**TECHNICAL & SAFETY COMMITTEE**  
**INTERNATIONAL PARACHUTING COMMISSION (FAI)**

<p><b>Technical &amp; Safety Information Notice No.</b></p>	<p><b>01/2009</b> <span style="float: right;"><b>W.N. 22</b></span></p>
<p><b>Date of Issue</b></p>	<p><b>28 January 2009</b></p>
<p><b>Subject Matter and Applicability</b></p>	<p>Following a riser failure on a PA Talon, the Australian Parachute Federation’s Director Rigging, Jo Chitty, issued the following notice. This notice is of mandatory status for APF members, and it is being distributed by the Technical &amp; Safety Committee of IPC to alert skydivers worldwide to the issues concerned.</p> <hr/> <p style="text-align: center;"><b>IMPORTANT ANNOUNCEMENT FROM THE DIRECTOR OF RIGGING, AUSTRALIAN PARACHUTE FEDERATION.  MANDATORY INSPECTION OF ALL 3-RINGS PRIOR TO NEXT USE</b></p> <p><b>RISER FAILURE</b>  On Sunday 18 January 2009, a <b>PA Talon</b> riser failed on opening. It was the left riser with RSL fitted. The reserve was deployed into the trailing main by the RSL resulting in a main reserve entanglement. Fortunately and with luck the jumper managed to attain sufficient reserve inflation to survive the landing with broken bones in his

**Typical view of locking loop length**

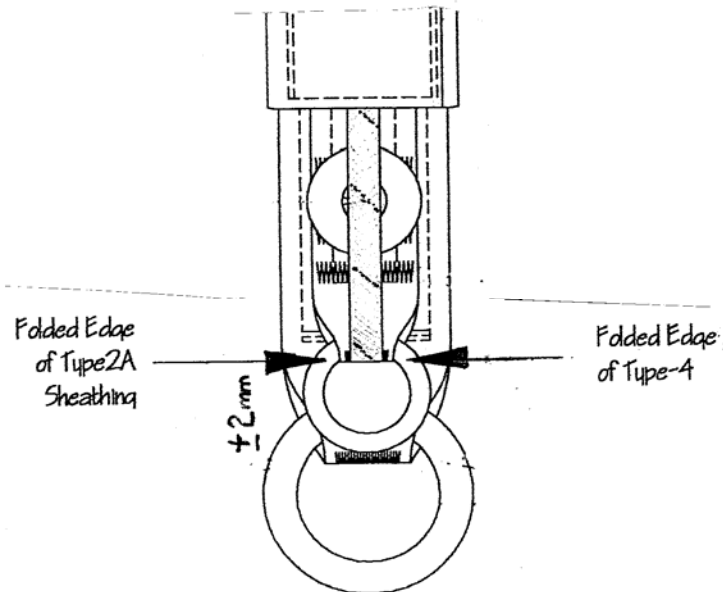
In August 2001 the APF promulgated APF Service Bulletin No APF010801-A 3-ring Inspection And Maintenance. The inspection, Part A, is designated **Mandatory**. This rig's reserve had been packed six times since the service bulletin was published, and numerous other times when the main was packed and possibly the 3-rings serviced. Had the service bulletin been applied it would have highlighted that the riser did not meet the criteria of the service bulletin; **the locking loop was too short.**

Due to the unique method of construction on this riser of bar-tacking across the loop it is probable that over a period of jumps some of the stitches had broken, due to the excessive load applied by the short locking loop until on this jump they failed completely allowing the loop to pull out of the riser, releasing it. It is impossible to visually inspect the stitching as it is covered by the confluence wrap; failure comes without warning signs. There was no kink in the left cutaway cable to warn of excessive loading. To prevent a similar event occurring especially when an RSL is fitted the following must occur.

**MANDATORY INSPECTION** in accordance with APF Service Bulletin [APF010801-B](#)\* Issued 23<sup>rd</sup> January 2009 of all 3-ring riser assemblies before the next jump. Inspection to be noted on reserve packing card and marked on inside of front riser with APF010801-B using a fine tip paint pen so it will be visible even if the risers are black.

On all solo rigs and all types of riser style, one inch type 17 mini rings, type 8 mini rings and standard type 8 with the larger rings, the length of the locking loop should be level (+/- 2mm) with the end of the fold of the webbing that retains the small ring when the riser is laid flat with some tension applied to the small ring.

It is normal for new type 17 mini risers to be tight to interlock the rings, this is because they become more pliable with use, but the locking loop must still allow the housing some play and not pull the small ring against the riser, see side view on service bulletin.
